Access Compliance Report

Public Rights-of-Way

(Curb Ramps)

Intersection ID: 7306	Main Street: CLEARVIEW_DR	Cross Street: DAWNSHIRE_AV	Location: NW
ADA ID: 10EA65BAB934	Ramp Type: BlendTrans1	Initial Pass/Fail: Pass	Overall Compliance: No
		Severity Score: 15

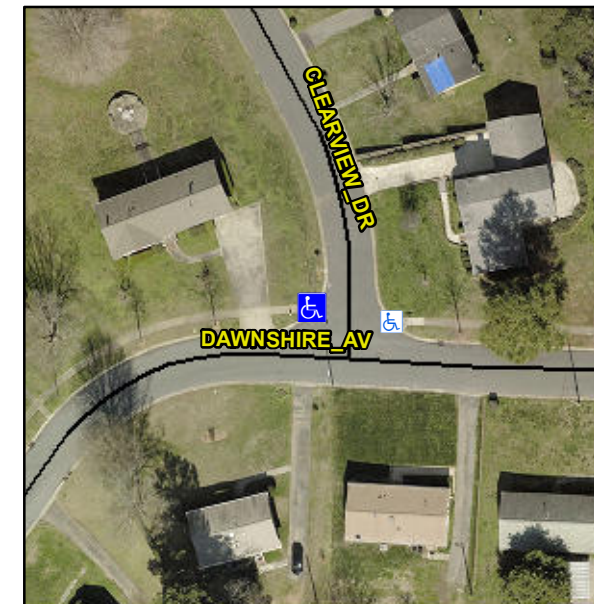
Not Found, R304.2.1, R305.2, R302.7.2

Compliance	Description	Data	Compliance	Description	Data
N/A	Ramp Length (in)	38.0	Yes	BlendTrans Slope (%)	4.0
Yes	Ramp Width (in)	48.0	Yes	BlendTrans XSlope (%)	1.5
N/A	Flare Type LT	Sloped	N/A	Flare Type RT	Sloped
N/A	Flare Slope LT (%)	0.1	N/A	Flare Slope RT (%)	0.1
N/A	Flare Traversable LT?	No	N/A	Flare Traversable RT?	No
Yes	Landing Length (in)	61.0	Yes	DWS Provided?	Yes
No	Landing Width (in)	47.5	Yes	DWS Contrast?	Yes
Yes	Landing Slope (%)	0.6	Yes	DWS Length (in)	24.5
Yes	Landing X Slope (%)	1.3	Yes	DWS Full Width?	Yes
N/A	Landing Curb? (Y/N)	No	No	DWS Offset (in)	3.0
N/A	Shared Landing?	No			
Yes	Gutter Ponding?	No	Yes	Gutter Slope (%)	0.6
No	Gutter Lip Ht (in)	4.0	Yes	Gutter X Slope (%)	0.7
N/A	Painted X Walk1?	No	N/A	Painted X Walk2?	N/A
	X Walk 1 Direction	To E		X Walk 2 Direction	N/A
	X Walk 1 Width (in)	N/A		X Walk 2 Width (in)	N/A
	X Walk 1 Slope (%)	6.3		X Walk 2 Slope (%)	N/A
	X Walk 1 X Slope (%)	4.8		X Walk 2 X Slope (%)	N/A

N/A	Ramp inside XWalk1?	N/A	N/A	Ramp inside XWalk2?	N/A
	Road Slope (%)	4.8		Clear Space?	Yes
	Road X Slope (%)	6.3	N/A	Clear Space to XWalk (in)	N/A
Yes	Any Obstructions?	No	Yes	Storm Grate/Utility Hazard?	No
	Obstruction Type			Storm Grate/Utility Type	
		N/A			N/A
			Yes	Surface Condition? (G/P)	Good
			No	Curb Slope (%)	10.5

Remove & Replace Curb Ramp With Two New Directional Ramps or Equivalent.
